MIAMI BEACH

Staff Report & Recommendation

Board of Adjustment

SUBJECT: **ZBA20-0111**
71 La Gorce Circle – Addition

ZONING/SITE MAP

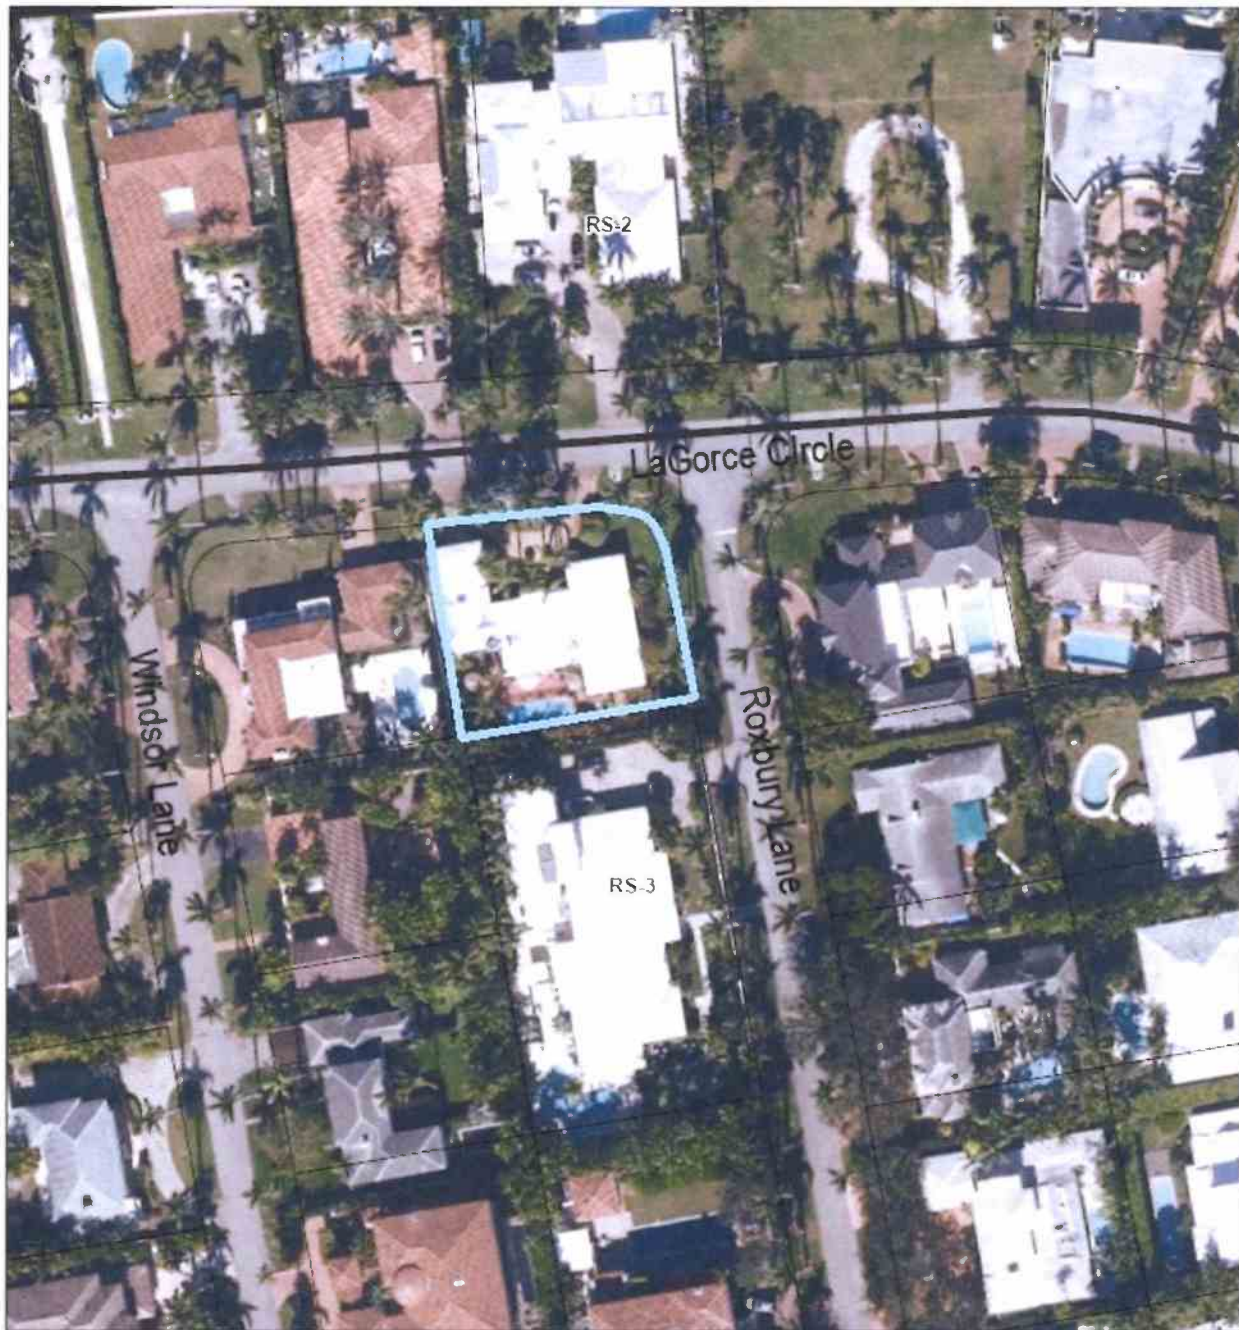
The location of the proposed addition is in line with the interior side of the existing home, and the encroachment into the rear yard is not visible from the public right of way, so there will be no impact when viewed from the street. The existing home is sited close to the southwest corner of an irregular lot and was originally constructed with a very small rear yard. The majority of the home's permeable open space is located in the front yard, which is treated as a street side yard. Staff would note that if the nonforming yard was considered an interior lot line, the City's Land Development Regulations would allow a one-story ground level additions to be constructed and to follow the existing interior building lines, provided a minimum side setback of five feet is met. As previously indicated, the proposed addition would meet this requirement with a setback of 5'-6".
